COMMITTEE REPORT

BY THE EXECUTIVE DIRECTOR FOR ECONOMIC GROWTH AND NEIGHBOURHOOD SERVICES
READING BOROUGH COUNCIL
PLANNING APPLICATIONS COMMITTEE: 31st March 2021

App No.: 200188/FUL

Address: 55 Vastern Road, Reading, RG1 8BU

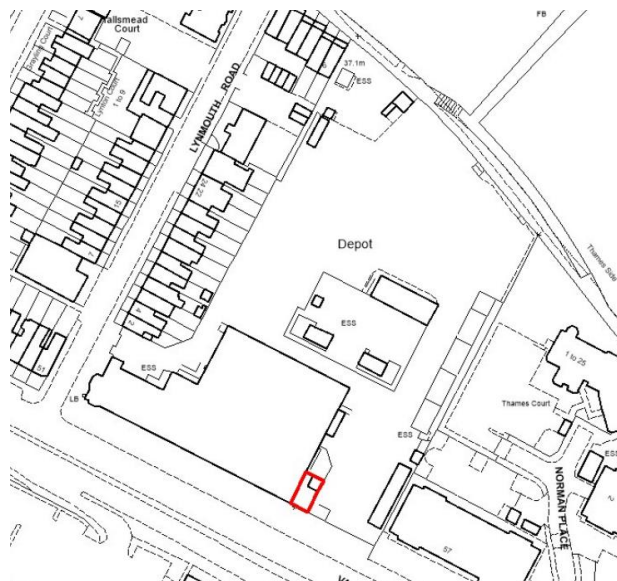
- 4.47 The comments on directness and visual links above also relate to the quality of the route. However, there is one additional point Planning Policy would wish to make on the quality of the link.
- 4.48 Planning Policy's main concern is width. The Policy Assessment Note emphasises that a minimum 3m width has been specified, and this appears to be the width through much of the site. It is worth comparing the proposed link with other pedestrianised town centre streets. Chain Street, for example, although 2.7m wide at its northern entrance, for most of its length exceeds 4m in width. Most of Union Street is up to 4m wide. Both of these streets have a distinct 'alleyway' feel, despite the buildings on either side being only 2-3 storeys, and cycling along them would be actively dangerous. Other town centre shared pedestrian/cycle routes, such as

Kennetside, are also wider than 3m. None of these are regarded as key through routes in the town centre. Christchurch Bridge itself is more than 4m wide, so the route would narrow from that point as it enters the site. A 3m width may fulfil technical specifications, but it does not recognise the vital, strategic nature of this route.

- 4.49 The narrowness of the site also very much limits the potential of the route to be anything other than a through route, and will not help it to be a useable part of the public realm for example sitting.

Access and Movement

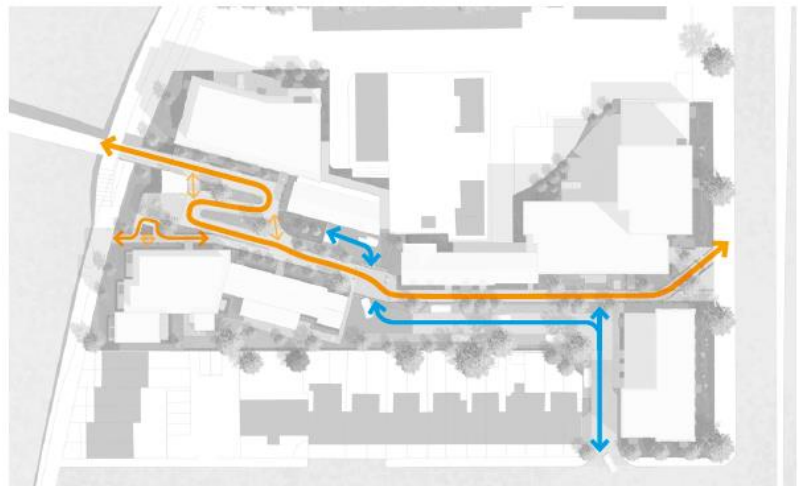
- 4.13.51 The Technical Note also contradicts the applicants Strategic Shared Cycle Footway document as it stipulates the route to the Towpath as being for cycles. An extract below of the document identifying this, for ease of reference, is provided below.
